UNITED STATES PATENT AND TRADEMARK OFFICE

APPLICATION NO.	FILING DATE	FIRST NAMED INVENTOR	ATTORNEY DOCKET NO.	CONFIRMATION NO.
09/935,687	08/24/2001	Boris Liberman	P-6126-US	3389
27130	7590	02/24/2005	EXAMINER	
EITAN, PEARL, LATZER & COHEN ZEDEK LLP 10 ROCKEFELLER PLAZA, SUITE 1001 NEW YORK, NY 10020			LIANG, LEONARD S	
			ART UNIT	PAPER NUMBER
			2853

Office Action Summary	Application No.		Applicant(s)	
	09/935,687		LIBERMAN, BORIS	
	Examiner		Art Unit	
	Leonard S. Liang		2853

DETAILED ACTION

FIG. 1

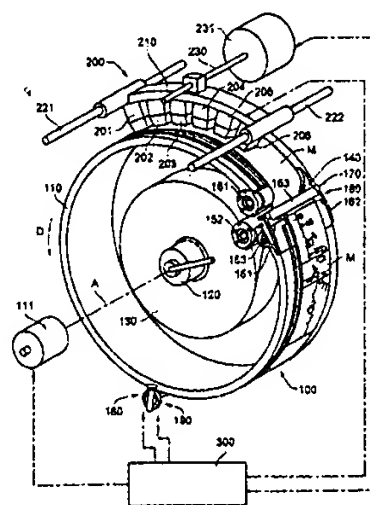
- {claim 1} A device upon which a flexible substrate is placed in order to be printed upon, the device being configured so as to create contact force between a supporting surface of the device and the flexible substrate (figure 1); a support structure configured so as to render the flexible substrate as a plurality of adjacent flat regions (flat regions defined as areas directly underneath individual

print heads), the flat regions being sequential along a feed path of the flexible substrate, each of the flat regions being positioned so that a vector following the feed path changes direction between the adjacent flat region in the sequence, the change of direction being a rotation about an axis that is perpendicular to the feed path and parallel to the surface of the flexible substrate, so that an entire surface of the plurality of flat regions, in combination, has a substantially convex profile (figure 1, reference 110; though mantle 110 is shown as a continuous strip, the examiner broadly interprets it as rendering the flexible substrate as a plurality of adjacent flat regions because the feed path vector along the surface of the substrate changes along the length of the substrate); a tensioning device configured so as to produce tension in the flexible substrate, the tension being along the feed path (figure 1, reference 160)

- {claim 2} a digital printing device including a plurality of print heads, the support structure being configured so as to provide one flat region for each of the printing heads (figure 1, reference 200-206)

- {claim 6} wherein the support structure is a substantially continuous solid structure fabricated with a plurality of the flat regions (figure 1, reference 101)

- {claim 7} wherein the tensioning device is integral to a feed and take-up device which moves the flexible substrate across the support structure (figure 1, reference 160)

- {claim 8} A device for applying print media to a flexible substrate (figure 1); a support structure configured so as to have a substantially convex profile onto which the flexible substrate is placed (figure 1, reference 101); a tensioning device configured so as to produce tension in the flexible substrate, the tension being along a feed path (figure 1, reference 160); a plurality of print heads deployed so as to align each of the plurality of print heads with a corresponding printing region on the flexible substrate, the print heads defining a printing plane, the printing planes being rotated in relation to one another, the printing plane including the corresponding printing region (figure 1, reference 200-206)

- {claim 9} wherein the support structure is configured so as to render the flexible substrate as a plurality of adjacent flat regions, the printing plane being coincidental with the flat region (figure 1; where flat regions are defined as areas directly underneath individual print heads)

- {claim 10} wherein the support structure is configured so as to render the flexible substrate as a substantially continuous curve, the printing plane being tangential to the curve (figure 1, reference 101)
